**NORTH STURBRIDGE ROAD SOLAR FACILITY**

**FIGURE 1:  
SWPPP  
INSPECTION  
SKETCH  
9/02/2021**

SHEET NO. **4**

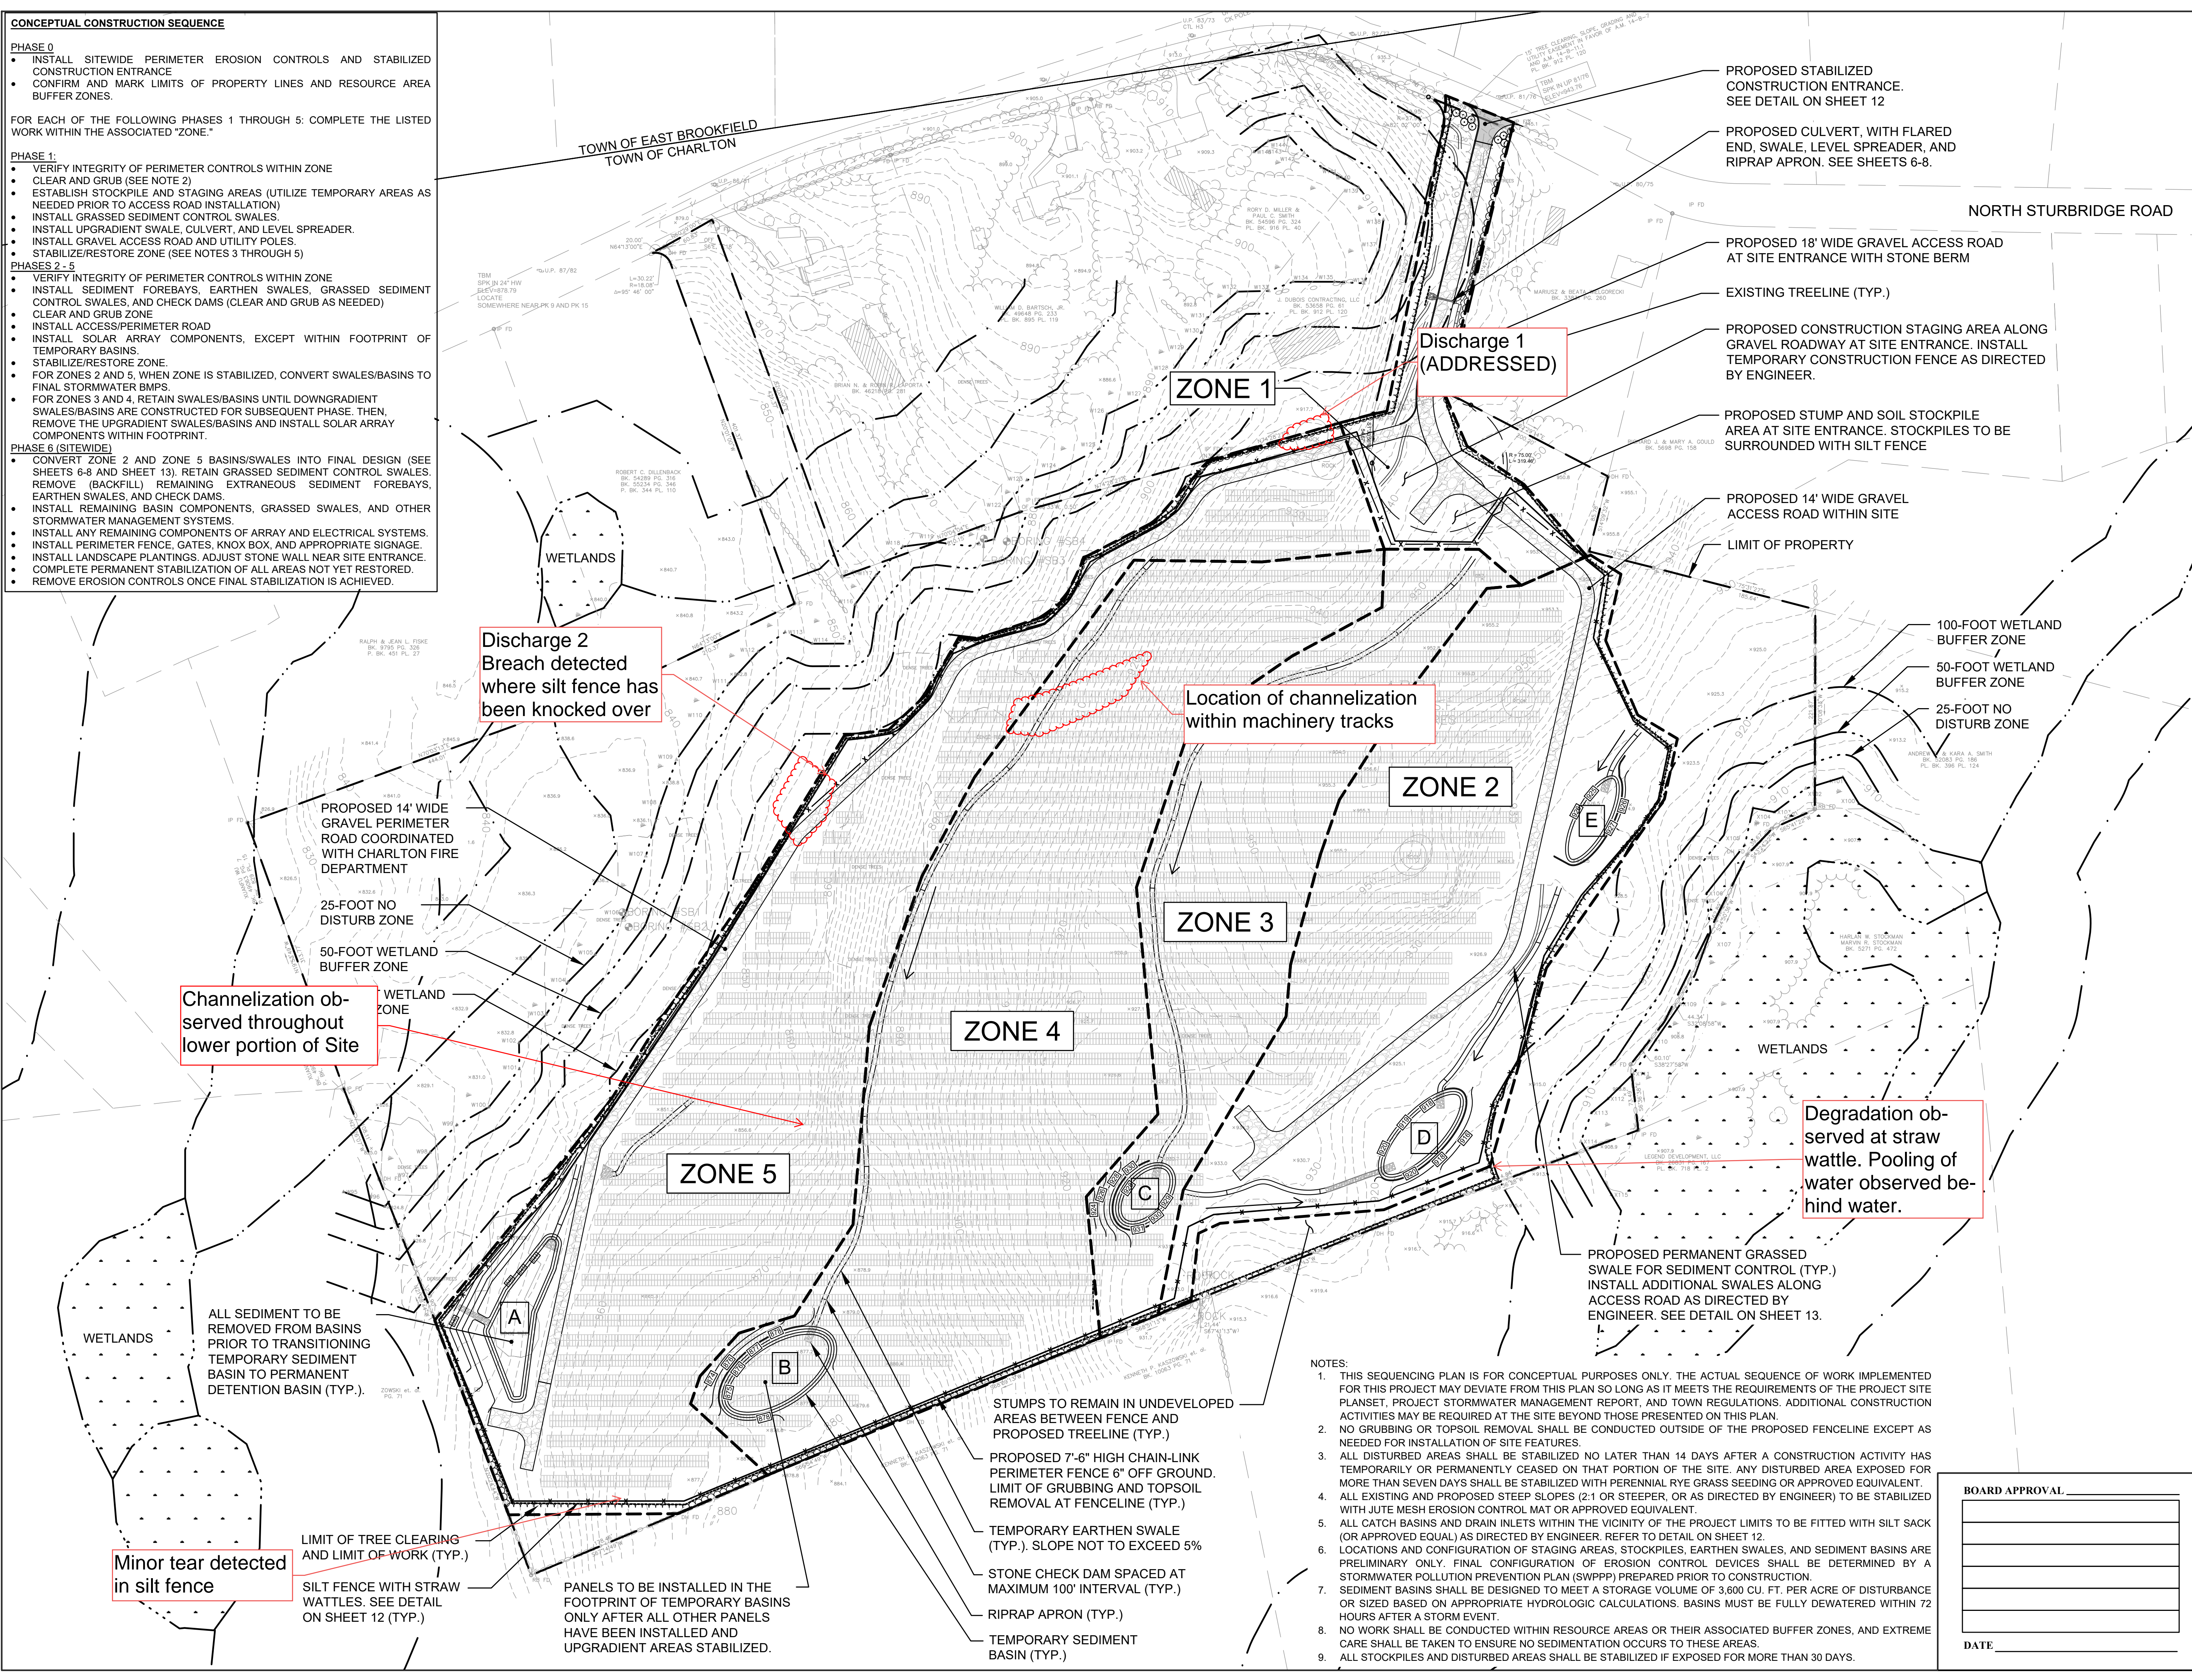
Degradation observed at straw wattle. Pooling of water observed behind water.
